# UNITED STATES PATENT AND TRADEMARK OFFICE

10/618,033

<b>Office Action Summary</b>	<b>Application No.</b> 10/618,033	<b>Applicant(s)</b> KEIDAR, YARON	
	<b>Examiner</b> ERIN COLELLO	<b>Art Unit</b> 3734

## DETAILED ACTION

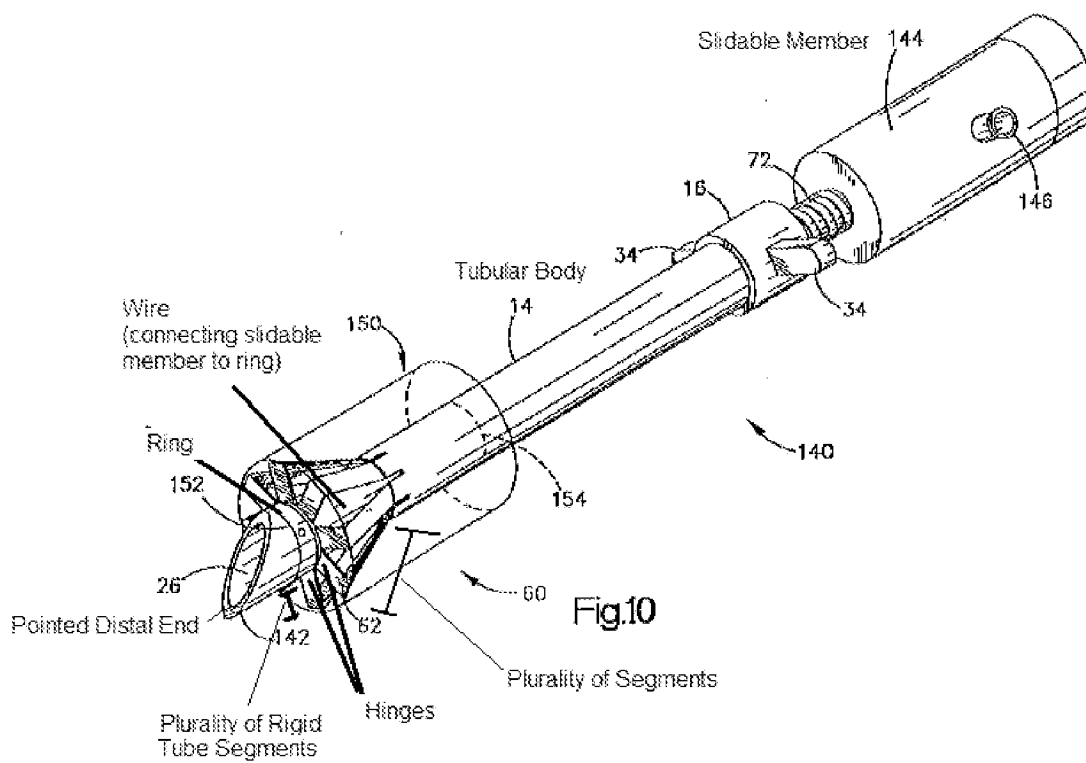
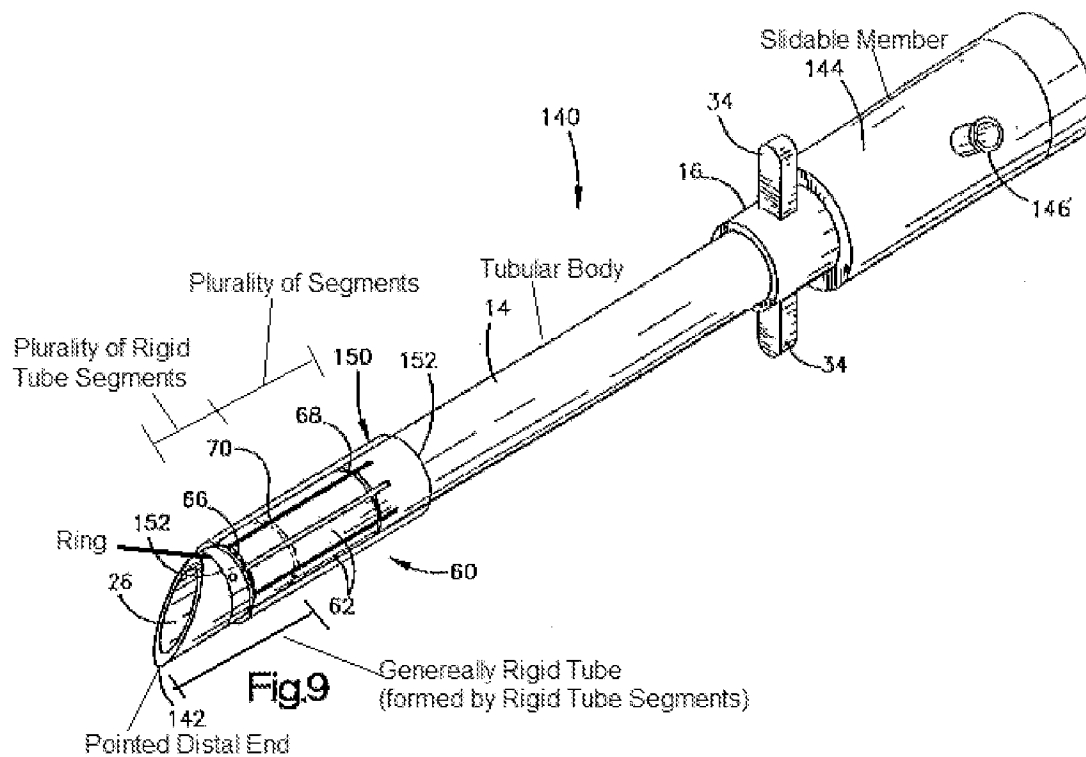
**Regarding claim 25**, Bonutti discloses a device comprising: an elongated, generally flexible tubular body (Ref 14); and a dilating tip (Ref 60) slidably mounted on a distal end of the tubular body (Ref 60, 14; wherein the distal end of the dilating tip slides relative to the distal end of the tubular body) and comprising: a segmented surface comprising a plurality of segments having proximal and distal ends (Ref 60, 62; Figures 9 and 10 see below), wherein the plurality of segments is configured to move between a closed configuration in which the segments combine to form the segmented surface (Ref 62, Figure 9 see below) and an open configuration in which the segments separate

from one another (Ref 62, Figure 10 see below); a plurality of generally rigid tube segments (Ref 62; Figures 9 and 10 see below), each tube segment extending distally from a segment of the segmented surface (Ref 62; Figures 9 and 10 see below), and wherein, when the plurality of segments is in the closed configuration, the plurality of tube segments combine to form a generally rigid tube (Ref 62; Figures 9 see below; wherein the plurality of tube segments form a portion of the generally rigid tube) having a sharp distal end configured to puncture tissue (Ref 142; wherein the generally rigid tube has a sharp distal end); and a ring (Figures 9 and 10 see below) slidably mounted to the tubular body (Figures 9 and 10 see below; wherein the ring slides relative to the distal end of the tubular body), wherein the distal ends of the segments of the segmented surface are hingedly attached to the ring (Ref 62; Figure 10 see below; wherein the distal ends of the tube segments are hingedly attached to the ring); wherein proximal movement of the ring relative to the tubular body exerts a force on the segmented surface to thereby open the segmented surface (Figures 9 and 10 see below; wherein (Ref 16) and (Ref 144) move relative to each other. Therefore when (Ref 16) is held, (Ref 144) can be rotated causing (Ref 144) to move proximally which triggers the ring to move proximally collapsing the dilating tip of the tubular body to thereby force open the segmented surface).

**Regarding claim 26**, Bonutti discloses a device comprising: an elongated, generally flexible tubular body (Ref 14); and a dilating tip (Ref 60) slidably mounted on a distal end of the tubular body (Ref 60, 14; wherein the distal end of the dilating tip slides relative to the distal end of the tubular body) and comprising: a ring mounted in surrounding relation to the distal end of the tubular body (Figures 9 and 10 see above); a segmented surface comprising three or more segments (Ref 60, 62), each segment being hingedly attached to the ring (Ref 62; Figure 10 see above), wherein the three or more segments are configured to move between a closed configuration in which the segments combine to form the segmented surface (Ref 62; Figure 9 see above) and an open configuration in which the separate from one another (Ref 62; Figure 10 see above); and three or more generally rigid tube segments (Ref 62; Figures 9 and 10 see above), each tube segment extending distally from one of the three or more segments of the segmented surface (Ref 62), wherein when the three or more segments are in the closed configuration, the three or more generally rigid tube segments combine to form a generally rigid tube (Ref 62; Figure 9 see above; wherein the plurality of tube segments form a portion of the generally rigid tube) having a sharp distal end configured to puncture tissue (Ref 142; wherein the generally rigid tube has a sharp distal end); a slidable member (Ref 144; wherein 144 slides relative to the tubular member) connected to the ring of the dilating tip (Ref 144; Figure 10 see above; wherein the slidable member is connected to the ring by means of the retractor body), wherein proximal movement of the slidable member relative to the tubular body exerts a force on the segmented surface and the generally rigid tube to thereby open the segmented

surface and the generally rigid tube (Figures 9 and 10 see above; wherein (Ref 16) and slidable member (Ref 144) move relative to each other. Therefore when (Ref 16) is held, the slidable member (Ref 144) can be rotated causing the slidable member (Ref 144) to move proximally which triggers the ring to move proximally collapsing the dilating tip of the tubular body to thereby force open the segmented surface).

**Regarding claim 7**, Bonutti discloses that the dilating tip is generally funnel-shaped (Figure 10, Ref 60).

**Regarding claim 14**, Bonutti discloses a wire (Figure 10 see above; wherein the retractor body is a long pliable metallic rod and therefore is being interpreted as a wire) extending proximally from the dilating tip to near the proximal end of the tubular body (Figure 10; wherein the wire connects the ring to (Ref 144; wherein 144 is near the proximal end of the tubular body) to effect proximal movement of the dilating tip relative to the tubular body (Figures 9 and 10 see above; wherein (Ref 16) and (Ref 144) move relative to each other. Therefore when (Ref 16) is held, (Ref 144) can be rotated causing (Ref 144) and the wire (Figure 10 see above; wherein the retractor body is a wire) to move proximally which triggers the ring to move proximally collapsing the dilating tip of the tubular body to thereby force open the segmented surface).

**Regarding claim 15**, Bonutti discloses a slidable member on the proximal end of the tubular body (Ref 144; wherein 144 is near the proximal end of the tubular body), the slidable member being connected to the wire (Ref 144; Figure 10 see above;

wherein the wire connects the slidable member (144) to the ring) so that proximal movement of the slidable member pulls the wire and causes proximal movement of the dilating tip relative to the tubular body (Figures 9 and 10 see above; wherein (Ref 16) and (Ref 144) move relative to each other. Therefore when (Ref 16) is held, (Ref 144) can be rotated causing (Ref 144) and the wire (Figure 10 see above; wherein the retractor body is a wire) to move proximally which triggers the ring to move proximally collapsing the dilating tip of the tubular body to thereby force open the segmented surface).

**Regarding claim 19**, Bonutti discloses that the slidable member (Ref 144; wherein 144 slides relative to the tubular member) is connected to the ring of the dilating tip by a wire having a distal end attached to the ring of the dilating tip and a proximal end attached to the slidable member (Ref 144; Figure 10 see above; wherein the retractor body is a long pliable metallic rod and therefore is being interpreted as a wire and connects the slidable member (144) to the ring of the dilating tip); wherein proximal

movement of the slidable member pulls the wire and causes proximal movement of the dilating tip relative to the tubular body (Figures 9 and 10 see above; wherein (Ref 16) and the slidable member (Ref 144) move relative to each other. Therefore when (Ref 16) is held, slidable member (Ref 144) can be rotated causing the slidable member (Ref 144) and the wire (Figure 10 see above; wherein the retractor body is a wire) to move proximally which triggers the ring to move proximally collapsing the dilating tip of the tubular body to thereby force open the segmented surface).
